# APPENDIX 110

## UNITIZATION PROCEDURES FOR BOXED AMMUNITION AND COMPO- NENTS ON 4-WAY ENTRY PALLETS

**FLARE, SURFACE-TRIP, M49 SERIES, PACKED 32  
PER WOODEN BOX, UNITIZED 18 BOXES PER 35" X  
45 1/2" PALLET; APPROX BOX SIZE 16 1/4" L X 15" W  
X 12 1/2" H**

**PALLET UNIT**  
SEE GENERAL NOTE "B" AT RIGHT.

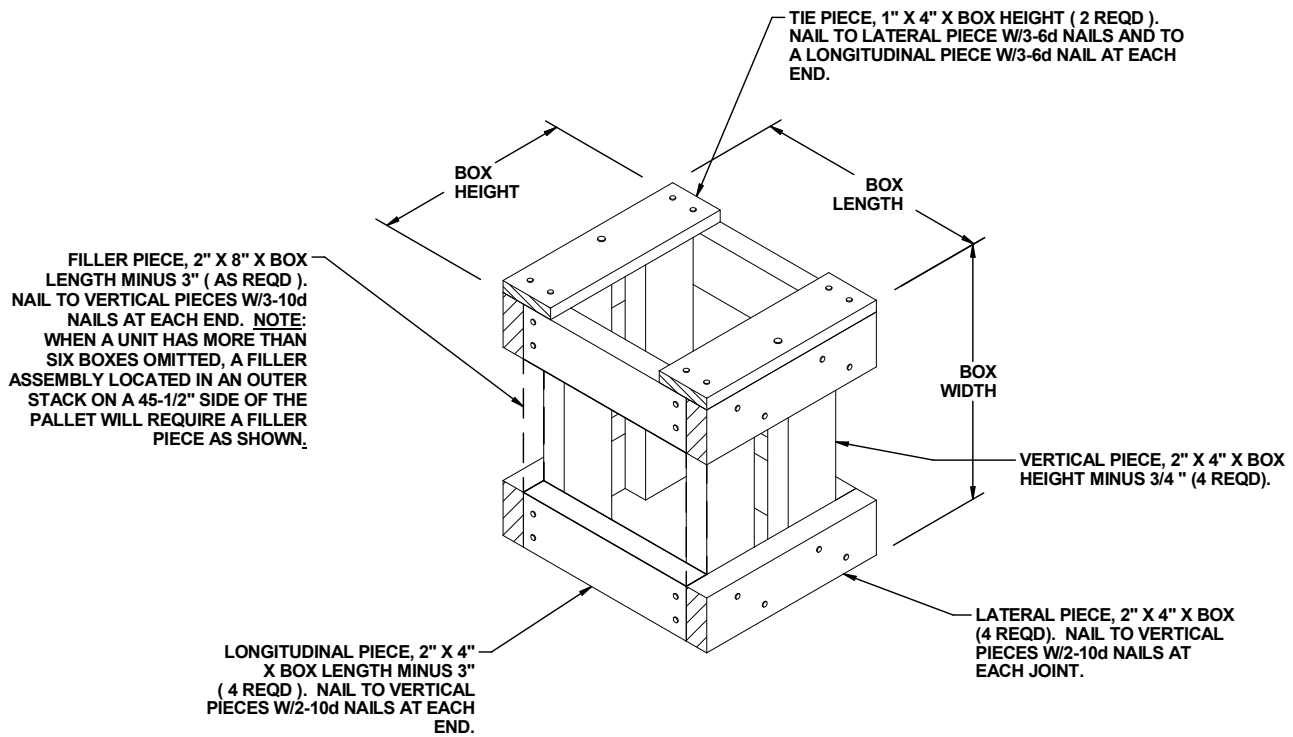
REVISION NO. 3, DATED JULY 2008, CONSISTS OF CHANGES PER ECP R07K3011 INCLUDING:

REORIENTING THE TOP CORNER BOXES ON THE PALLET UNIT.
